Russell Gap Stream Mitigation Project Year 4 (2023) Monitoring Report FINAL

Alexander County, North Carolina, Catawba River Basin: 03050101-120010

Response to DMS Comments (December 15, 2023) for DRAFT Monitoring Year 4 Report.
Russell Gap Mitigation Project, Alexander County
Catawba River Basin: 06010106
DMS Project #100003 DEQ Contract #6980

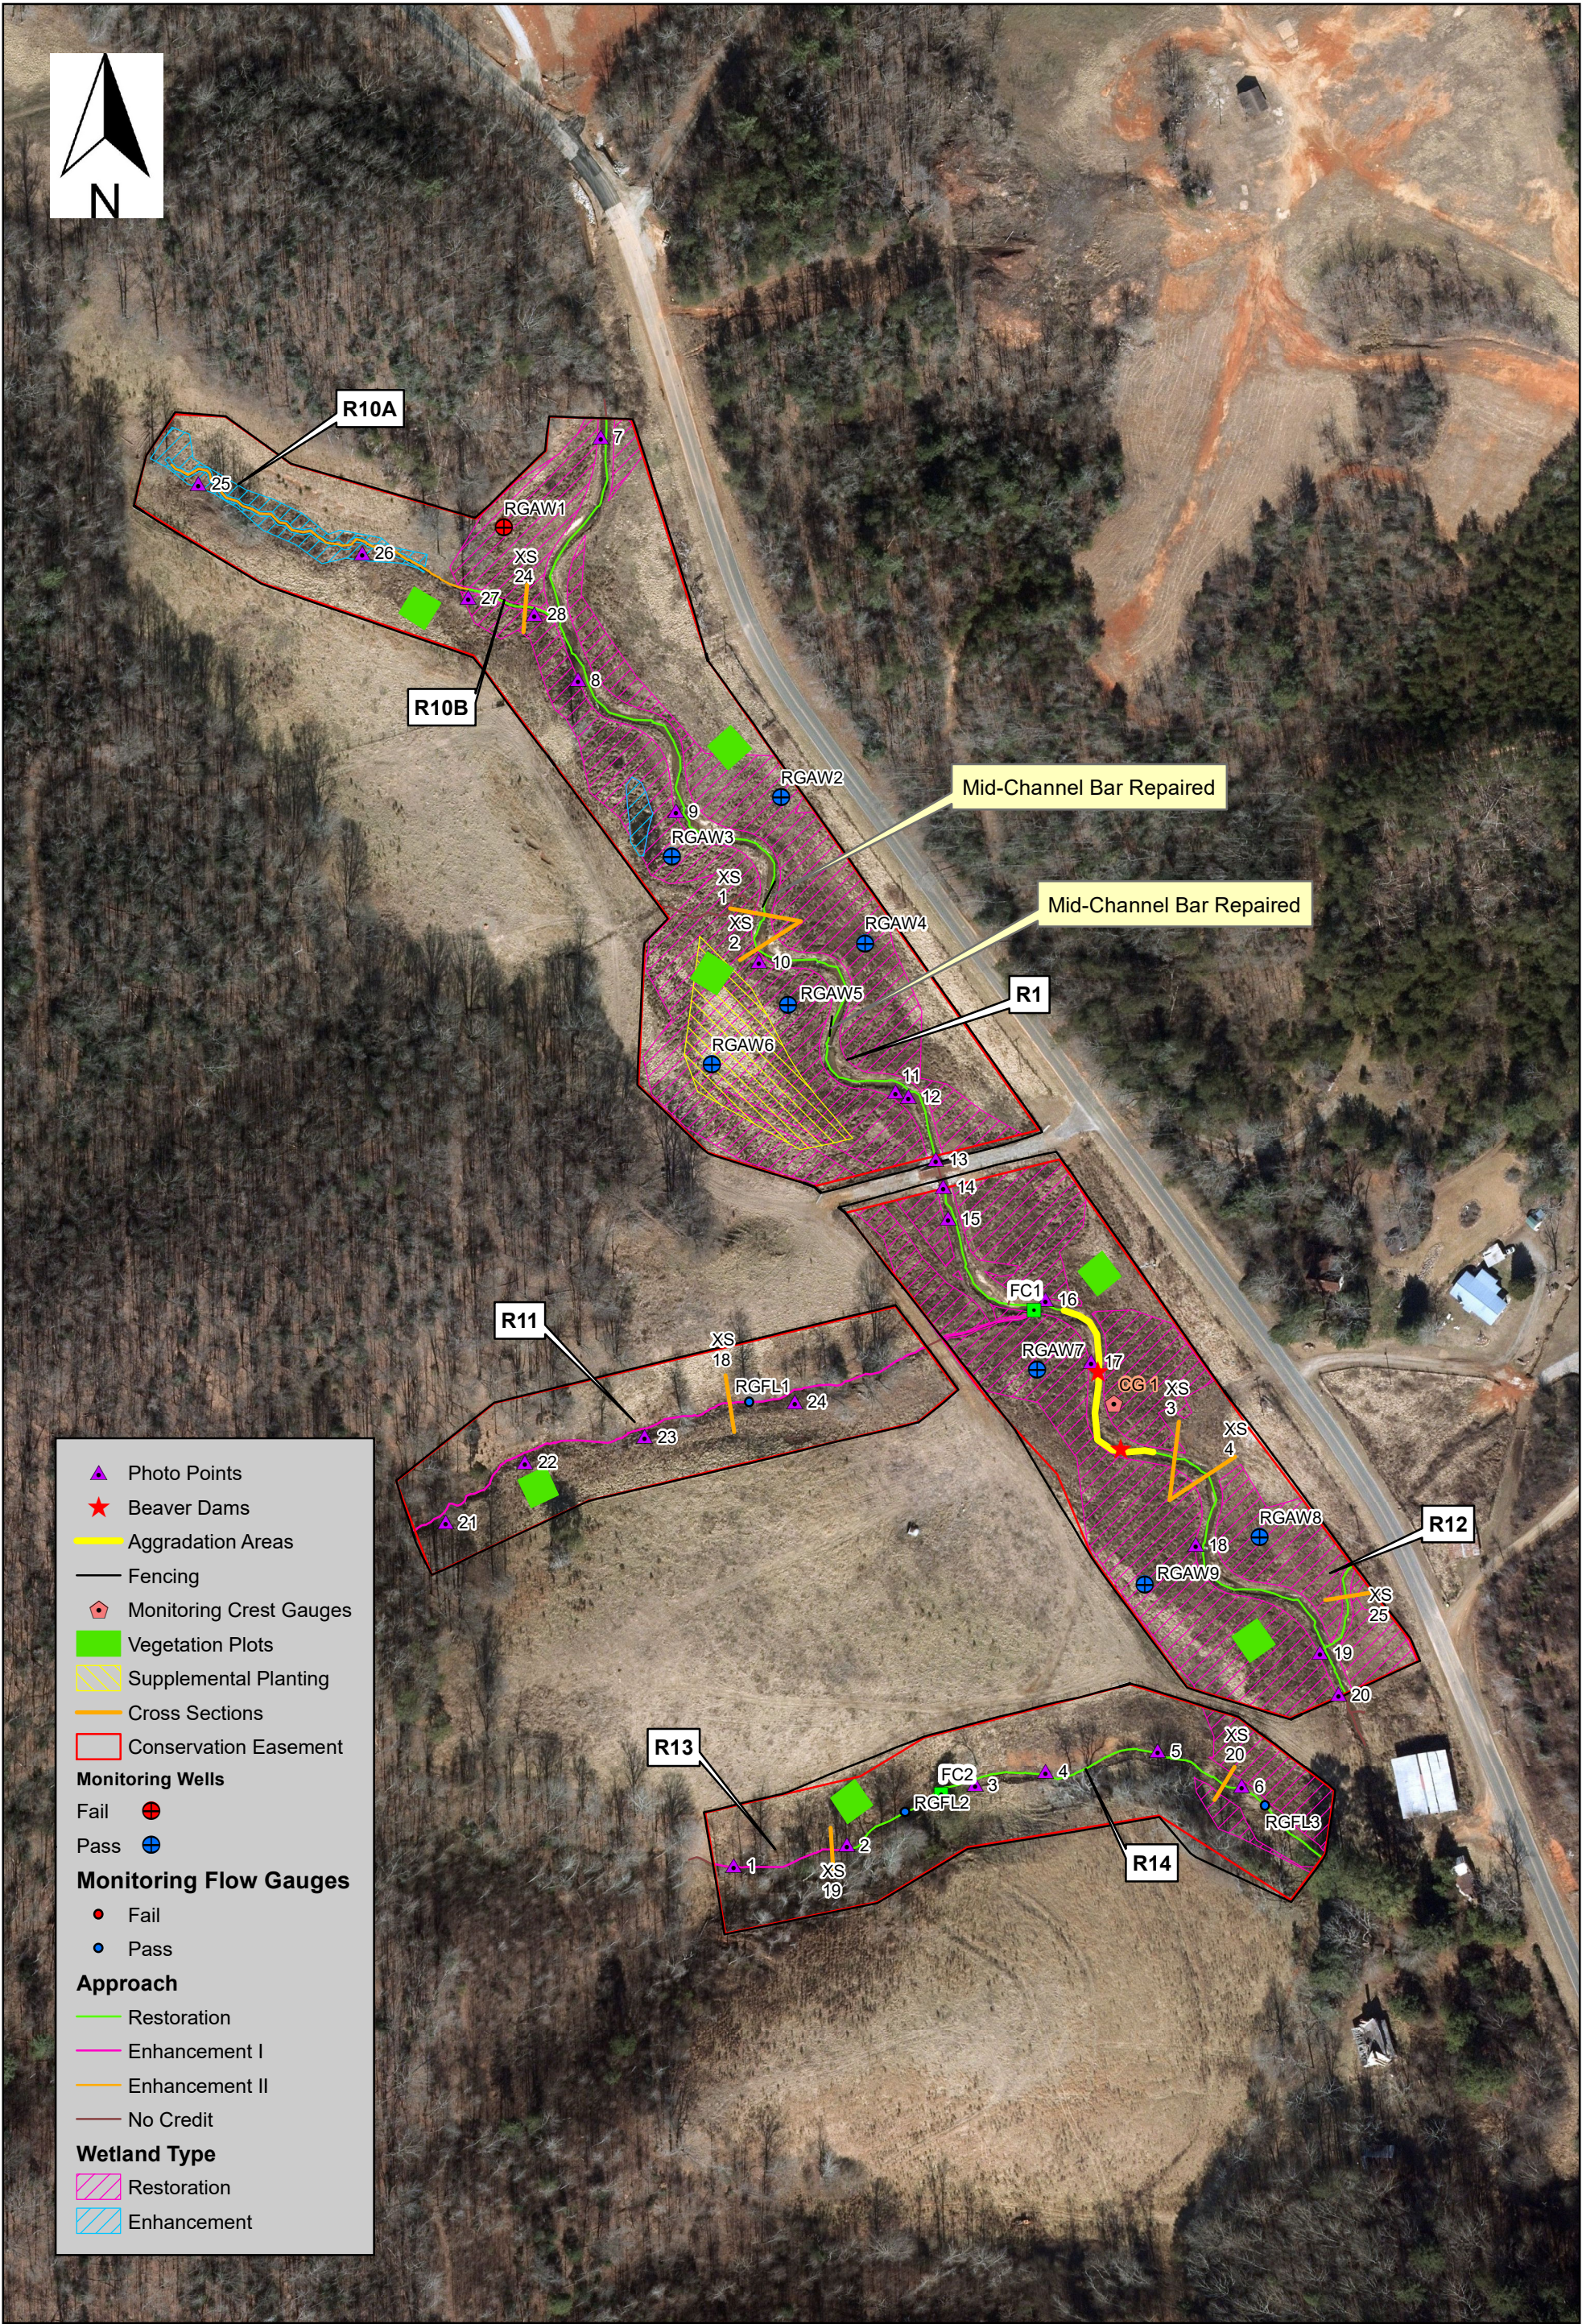
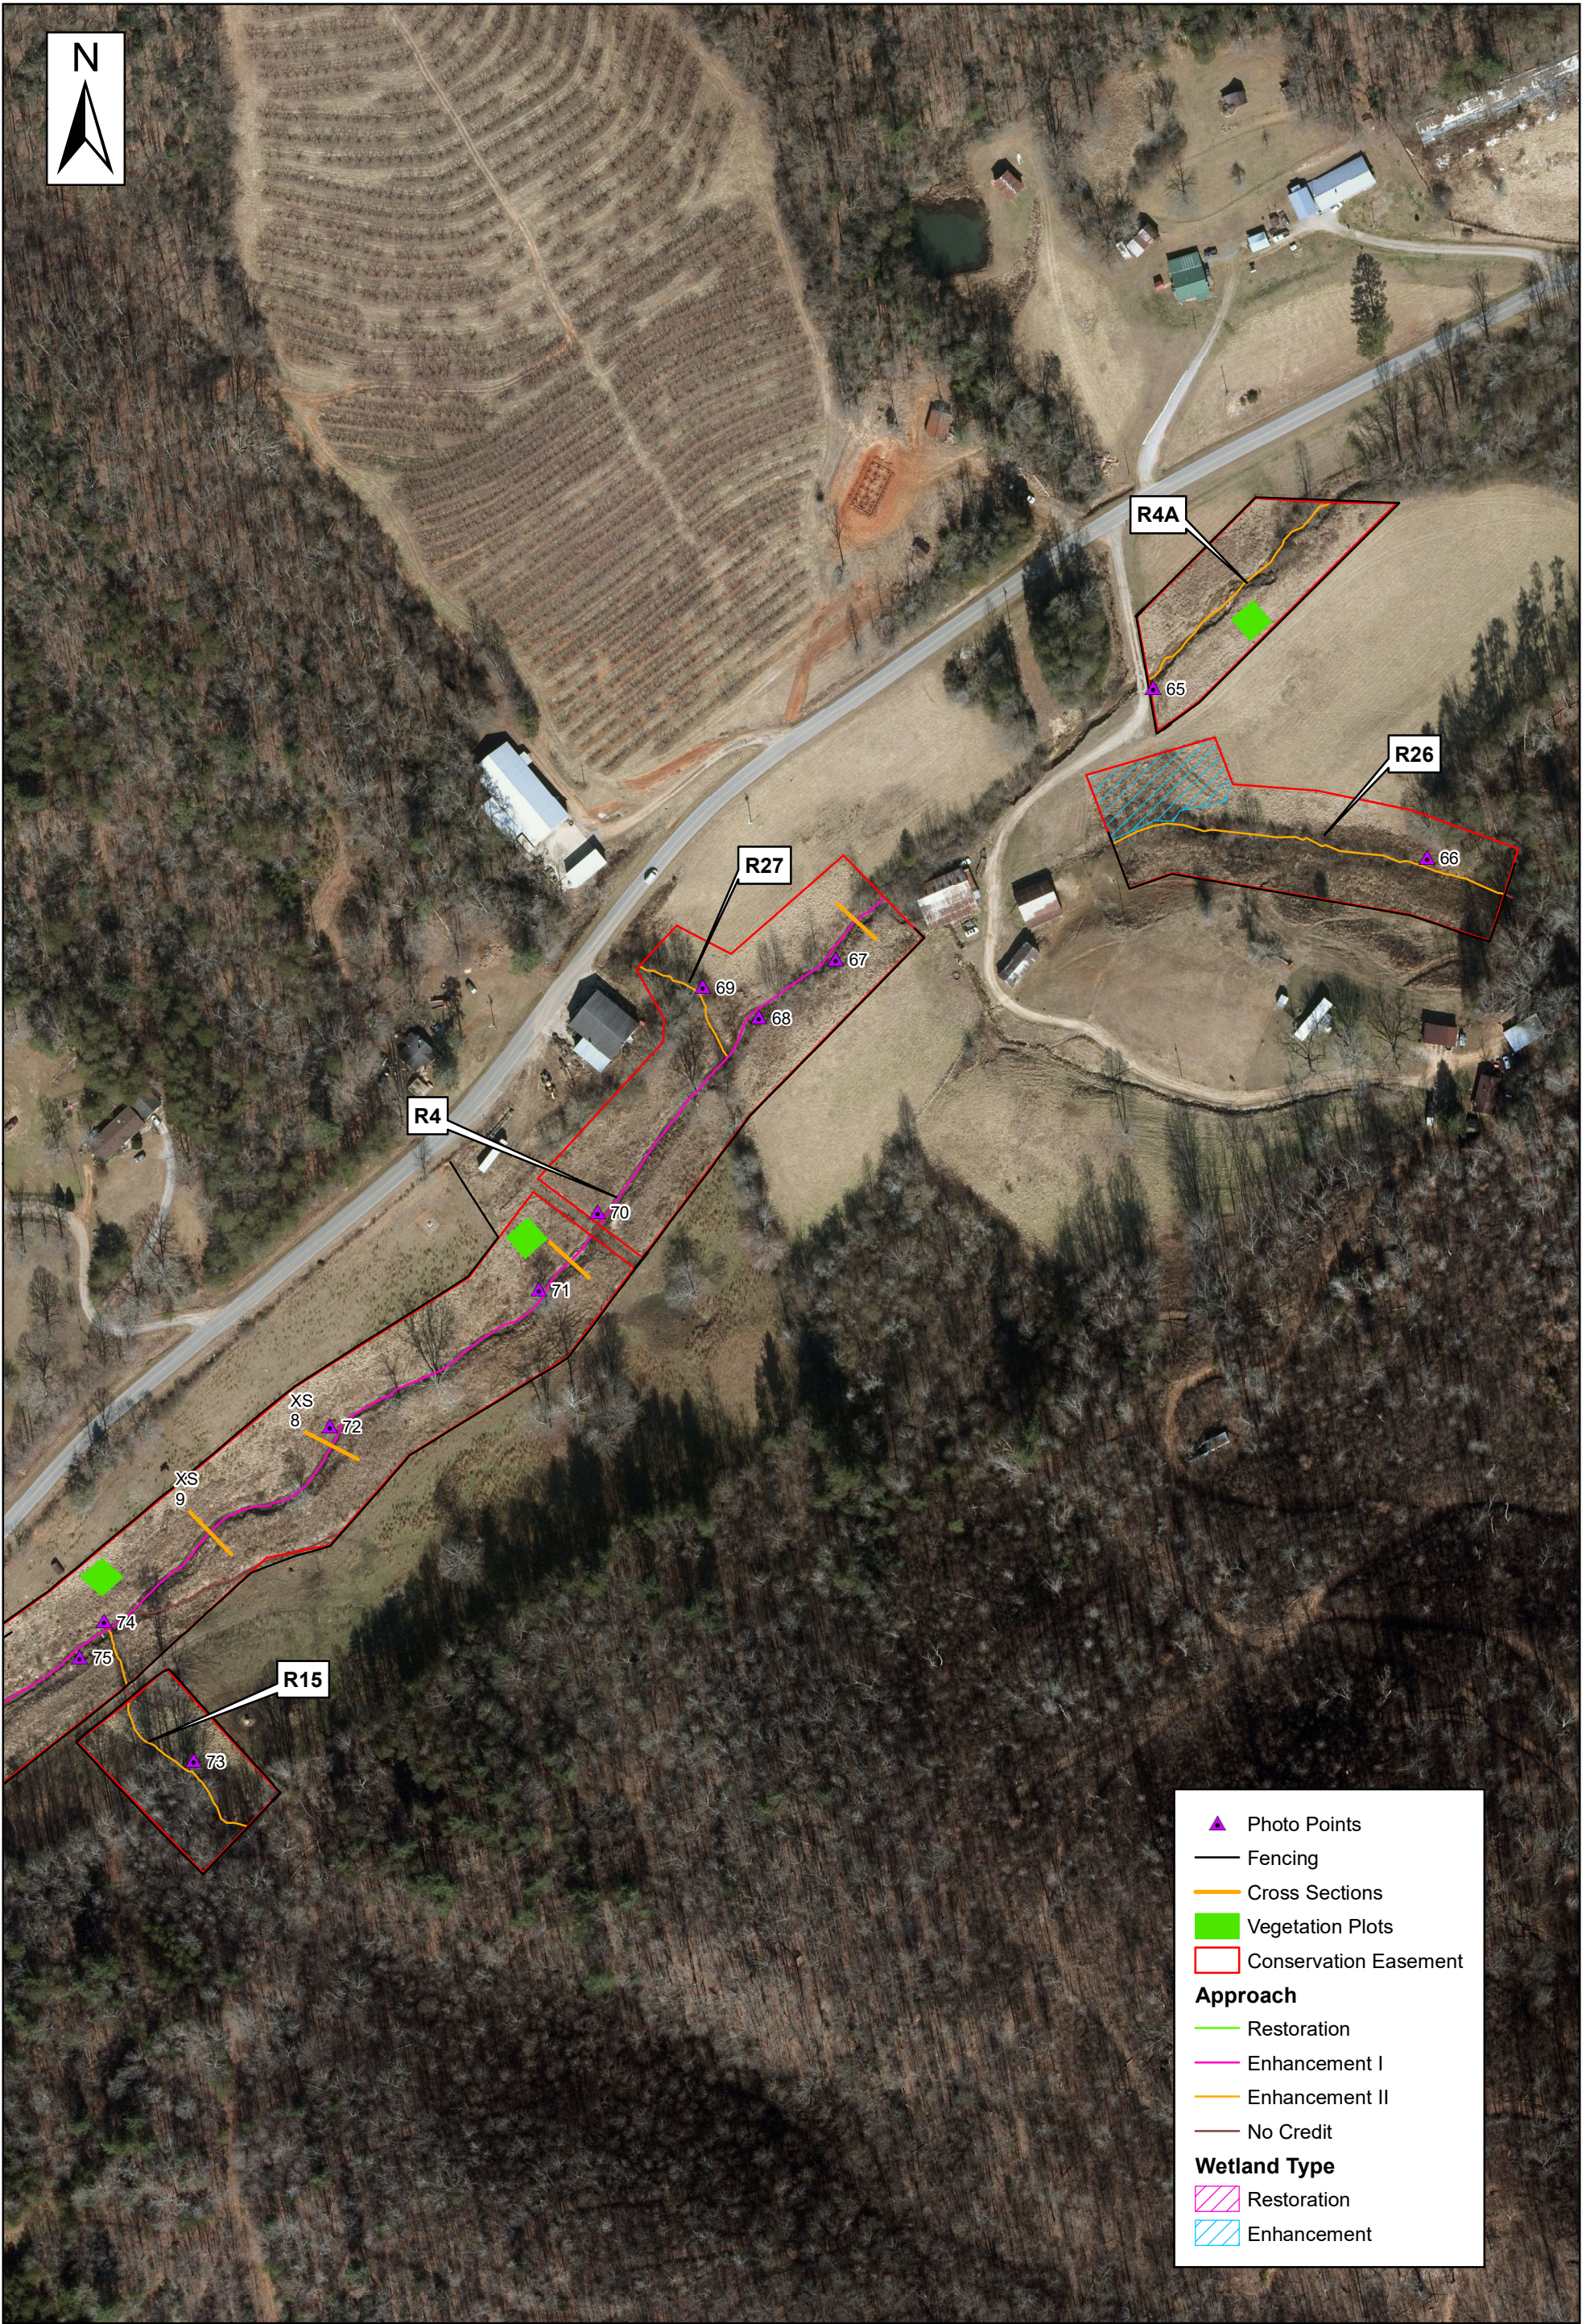
- Table 5, R1 – Table indicates 2 unstable segments totaling 220 feet. The CCPV does not show these segments. DMS assumes this aggradation is a result of the beaver dams. Please include these areas on the CCPV and include a .shp file in the revised submittal for the aggrading length.

- Table 5, R3, R4 and R9 – Same comment as above.
RESPONSE: See response above.
- Hydrology Gauge Graphs – DMS recommends downloading gauge data after the end of the growing season so the data set includes the entire growing season.

RESPONSE: These stream lengths are associated with the beaver dams and a line showing the approximate hydrologic impact has been added to the CCPVs. A shapefile has been added to the electronic submission files as requested.
